Town of Valdese
Public Safety Building Report
2021

Public Safety Building Timeline:

The Public Safety Building and Town Hall Building were investigated on February 5th 2018. Findings include multiple horizontal and vertical cracks in the interior wythes of the buildings. Cracks range from 1/16" to 3/8" wide. The horizontal cracks appear attributable to either expansive roof forces or contractive internal floor forces. Either cause would induce out of plane loading to create the horizontal cracks. The vertical cracks appear attributable to expansion and contraction forces within the walls. No vertical expansion joints were provided per Record Drawings nor per field observation. Lack of expansion joints or defects associated with horizontal joint reinforcing may have contributed to the cracks. The forces applied are likely on account of temperature, changes in moisture, and shrinkage.

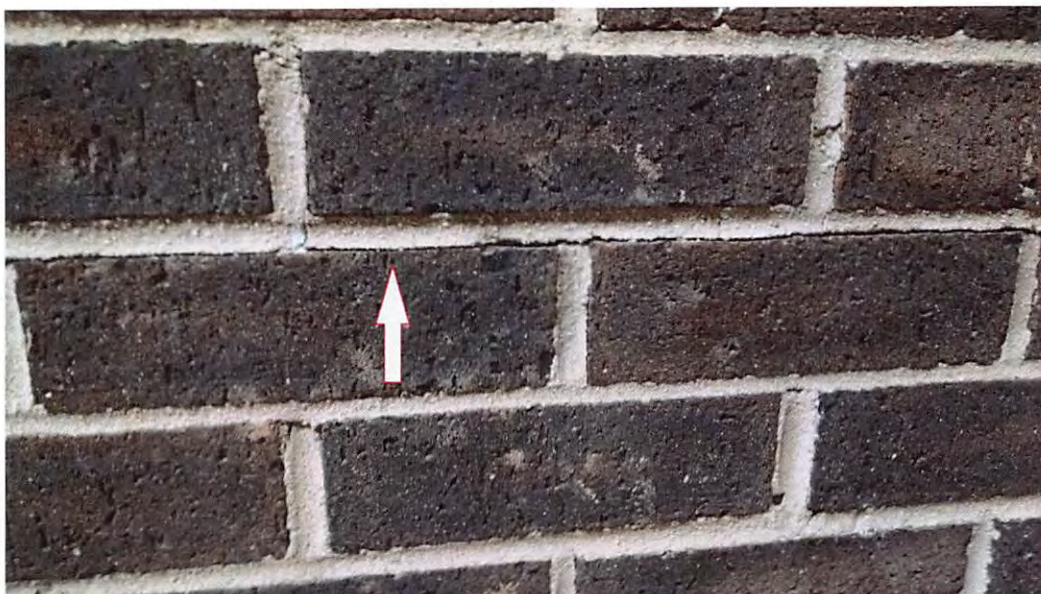
VERTICAL AND HORIZONTAL CRACKS IN WALL OF FIRE CHIEF'S OFFICE.
VERTICAL CRACK EXTENDS FROM FLOOR TO CEILING. THIS WALL IS AN
EXTERIOR WALL.

Photo 3 Town Hall – South Wall – Horizontal and Vertical Cracks

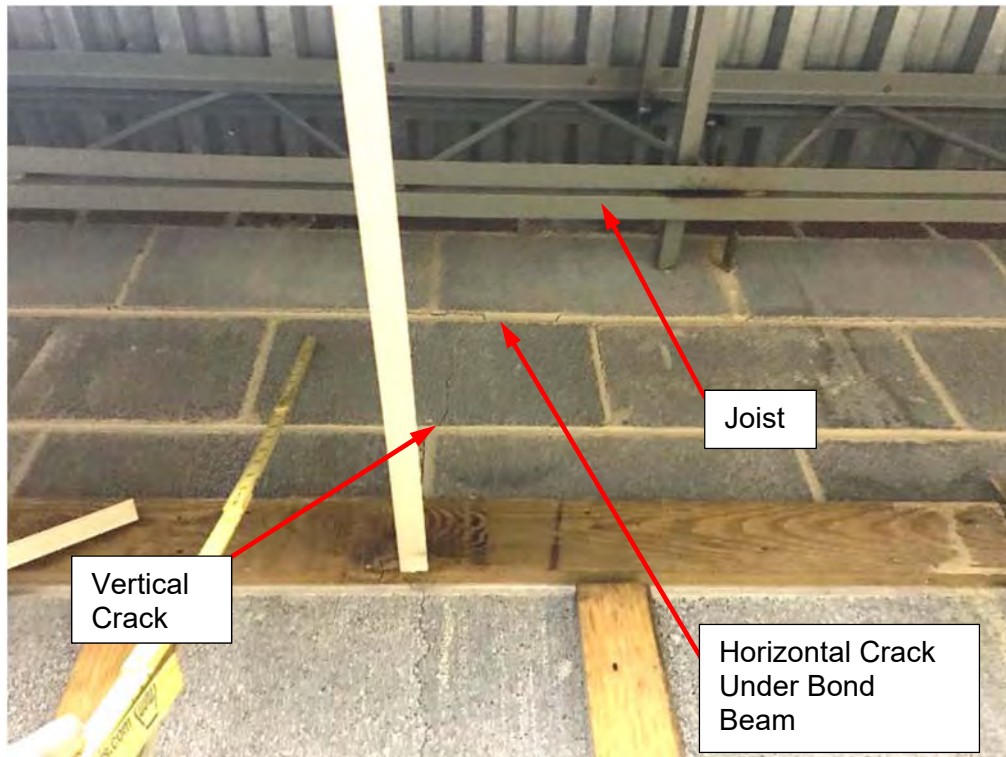
The horizontal cracks are typically located at the approximate elevation of the bottom of the steel reinforced Bond Beam, see Photo 3 and 4 and Figure 7. This condition persists along the north exterior wall and east exterior wall. Per Figure 7 from the Town Hall record drawings, the joint at the bottom of the bond beam is located at the crack elevation. In addition, the presumed horizontal joint reinforcing elevation is at the joint at the bottom of the bond beam. Horizontal joint reinforcing and the infilled bond beam appear to create a stress concentration at that elevation with respect out of plane loading.

Photo 11 Public Safety Building – Interior Slab – Crack

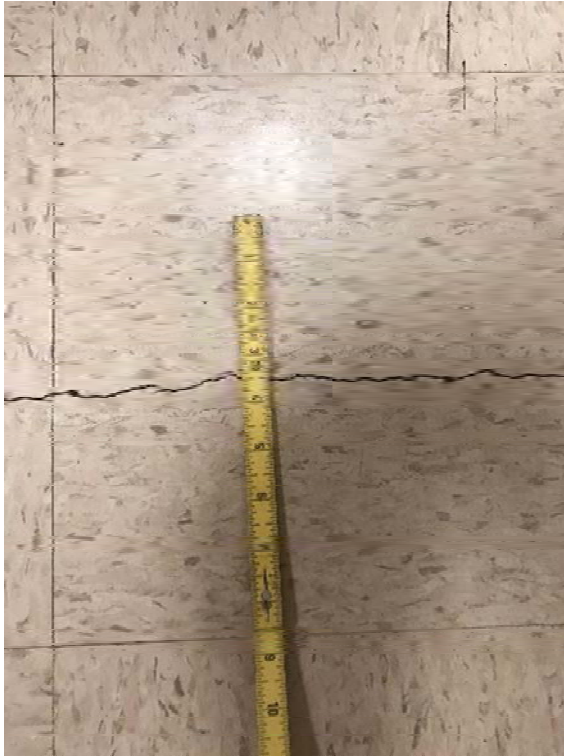
Some slab cracking is evident through the linoleum tile in interrogation, Photo 11. The cracks appear isolated. Separation is evident between the slab and the wall along the east wall as shown in Photo 27. The separation may be attributable to the same forces acting out of plane on the walls to create the horizontal crack.

Photo 12 Public Safety Building – South Wall – Horizontal Crack

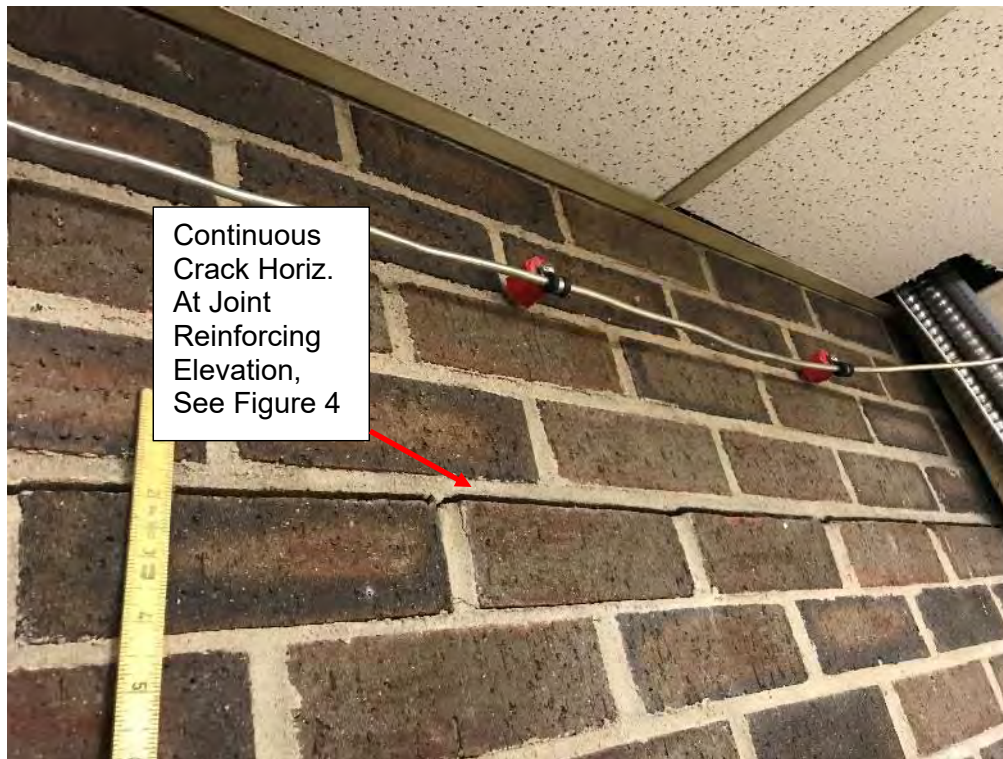
A horizontal crack runs virtually the entire perimeter of the building and is located approximately 4 ½ bricks below the drop ceiling on the east wall the south wall and part of the north wall per Photos 12 and 13. The west wall horizontal crack elevation varies to approximately 10 ½ bricks below the drop ceiling which is consistent with a horizontal joint reinforcing spacing of 16". Similarly, 4 ½ bricks below the drop ceiling is consistent with joint reinforcing detailed in Figure 4 per Record Drawings.

FIGURE 8

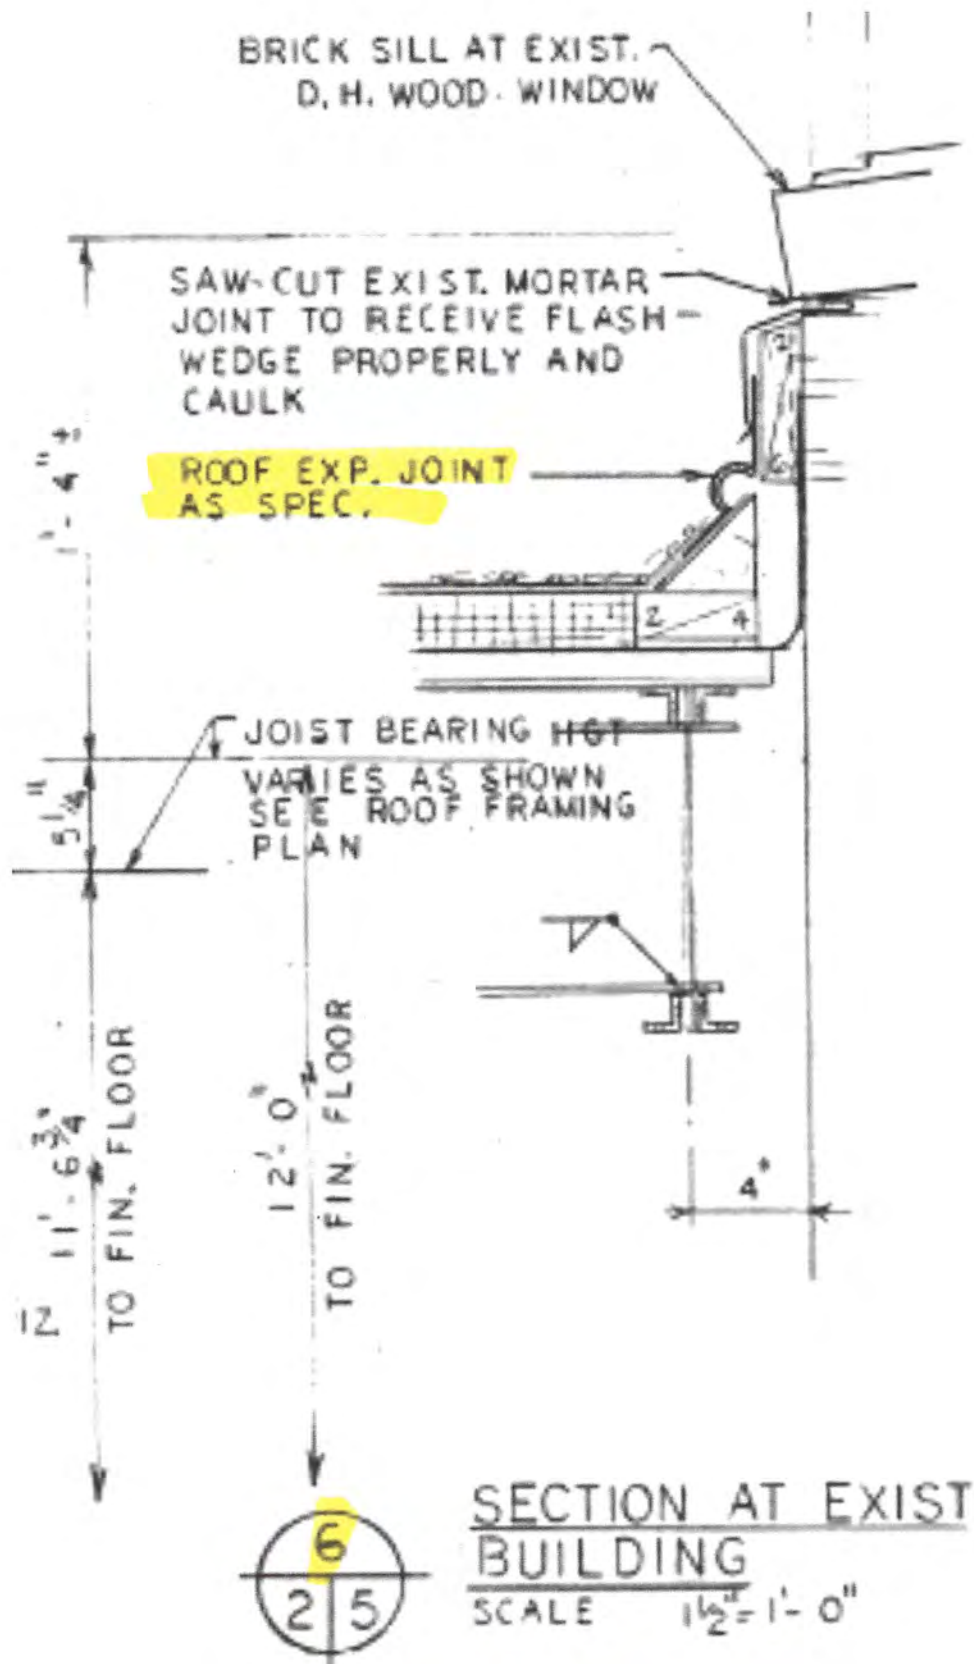
The roof was equipped with one expansion joint per record drawings and shown in attached Figure 8. The expansion joint is located along the south wall which is shared by the old previously existing Firehouse building. No expansion joints were provided, per record drawings, at either the east or west walls. It is clear that expansive forces should be expected in the east to west direction. It is less clear why expansive forces effected the horizontal crack in the north wall since expansion forces should have been partially alleviated by the joint at the south wall. It is possible the joint was either installed incorrectly or was less effective than the designer's intent.

Photo 3 Town Hall – South Wall – Horizontal and Vertical Cracks

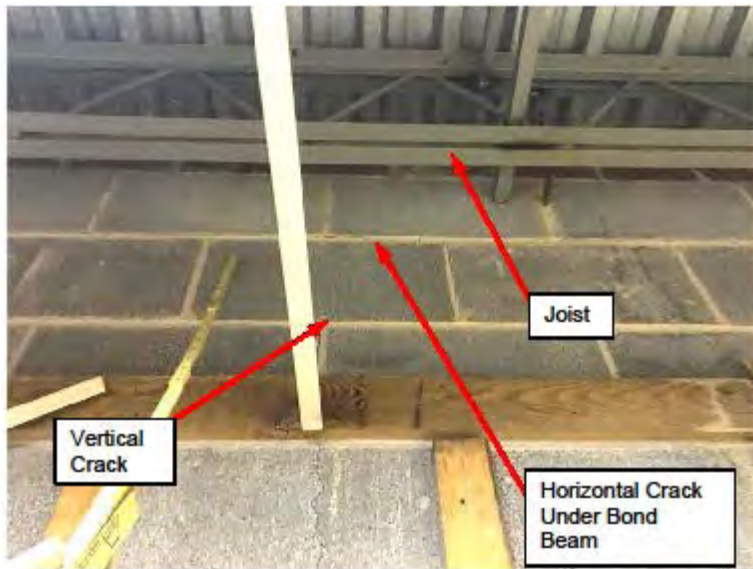
Cracks extend up to masonry block bond beam.

Horizontal cracks occur at bottom of masonry bond beams, separating bond beams from supporting walls.

Photo 9 Public Safety Building – West Wall – Horiz./ Vertical Cracks

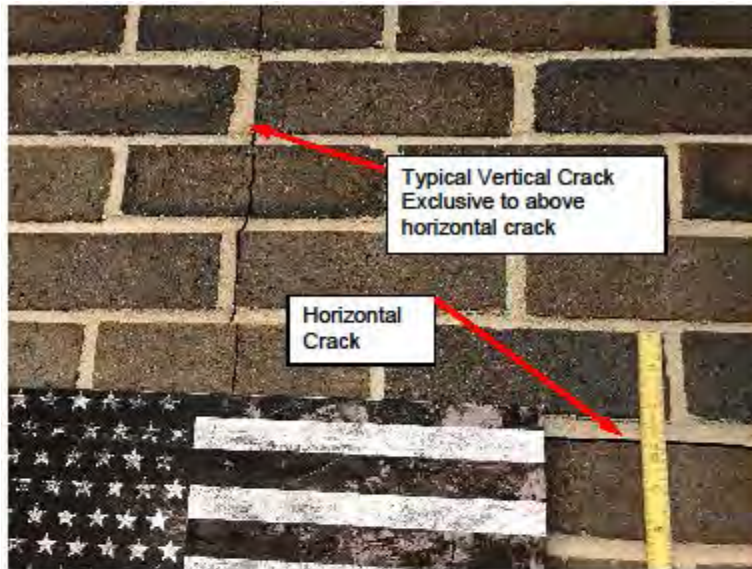
Vertical and horizontal cracks in load bearing double wythe brick wall.

Some vertical cracks run full height of wall on interior of building.

Photo 15 Public Safety Building – South Wall – Deteriorated Joints

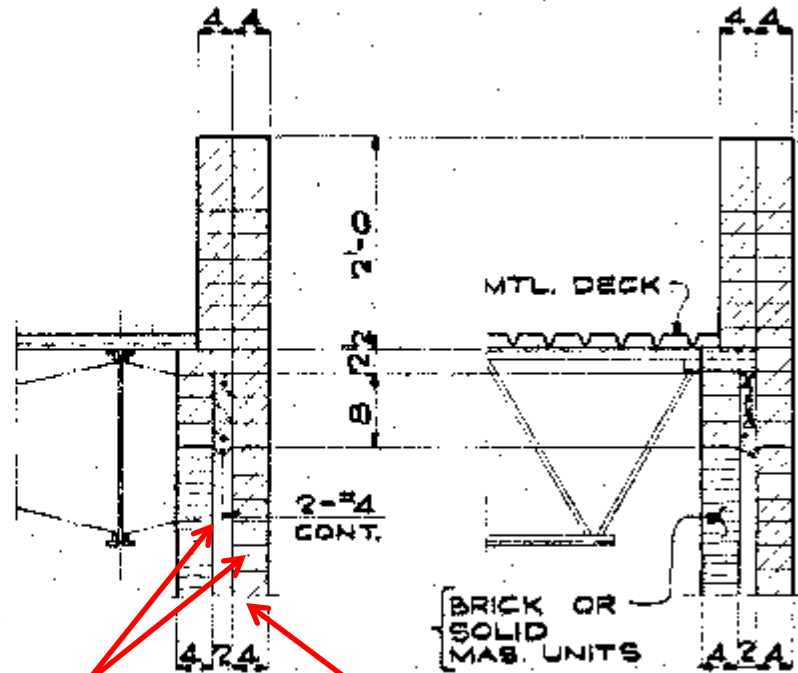
Exterior horizontal cracks at 16" on center at each band of steel ties.
